Palo Verde Nuclear
Generating Station

**Subject: Palo Verde Nuclear Generating Station (PVNGS)
Units 1, 2 and 3
Docket Nos. STN 50-528, 50-529, and 50-530
Redacted Version of Proprietary Submittal Dated February 24, 2005
Regarding ECCS Pump Testing and Safety Significance Assessment**

**Redacted Version of Proprietary Enclosure 2 of APS
Letter No. 102-05217, Dated February 24, 2005, Regarding ECCS Pump
Testing and Safety Significance Assessment**

Enclosure 2
Arizona Public Service Company
Responses to Request for Additional Information Regarding ECCS Pump Testing
and Safety Significance Assessment

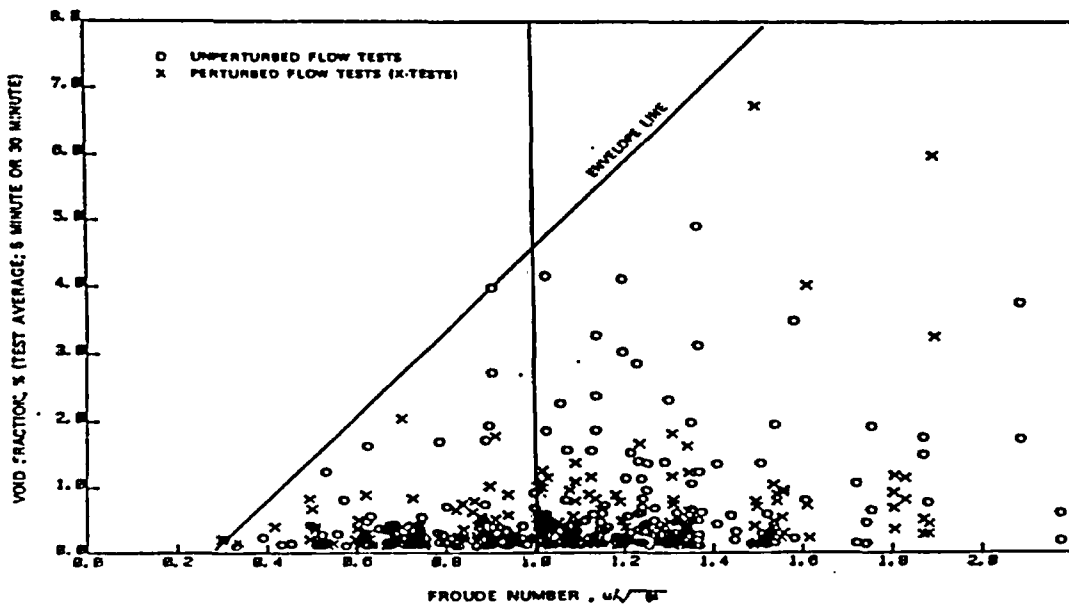
Discuss the appropriateness for use of the Froude number to scale model test the 45 degree downward sloped CS branch connection.

It was suggested by the NRC that a similar reduction in the CS branch connection would also seem necessary since the flow in this section of the piping was not horizontal. However, during the performance of the scale model testing, no such [] occurred in the 45 degree downward sloped segment of the CS branch connection. Without any observed non-conservative or non-prototypical behavior being exhibited in the tests, there was no need or justification to depart from the Froude number.

demonstrates the necessity of maintaining the Froude number to ensure representative behavior of vortex formation and air entrainment into the CS line.

CLOSED CONDUIT FLOW

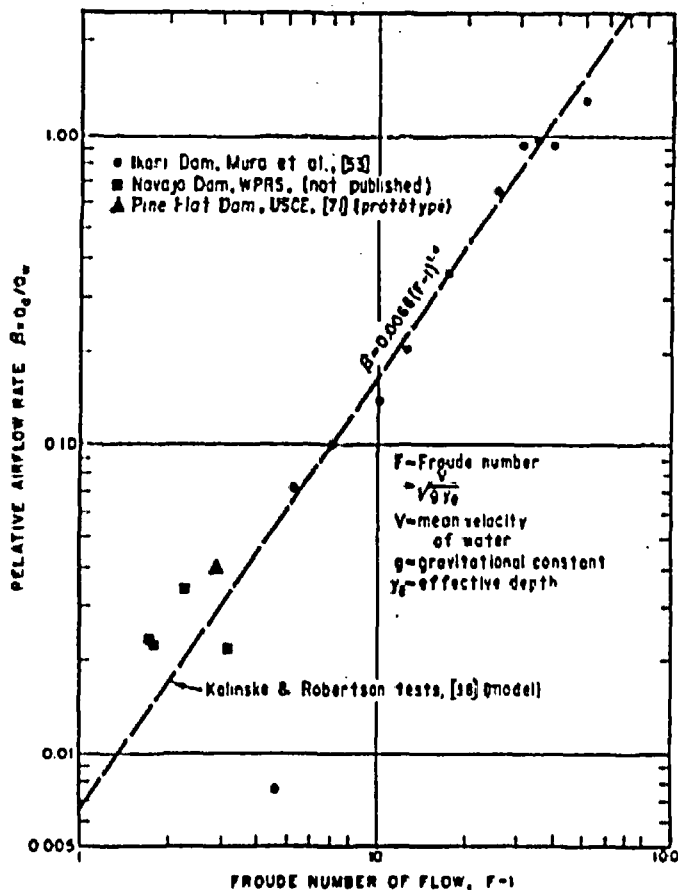
The NRC requested the information that was referred to in the conference regarding information from the Hydraulics Industry on air transport in large pipes.

A good discussion regarding air transport in large pipes is provided in "Air-Water Flow in Hydraulic Structures", Engineering Monograph No. 41, United States Department of the Interior, Water and Power Resources Service. A copy of this paper is attached to this submittal.

[Again, the correlations described are based on Froude number or on dimensionless water flow rates that are proportional to Froude number.]
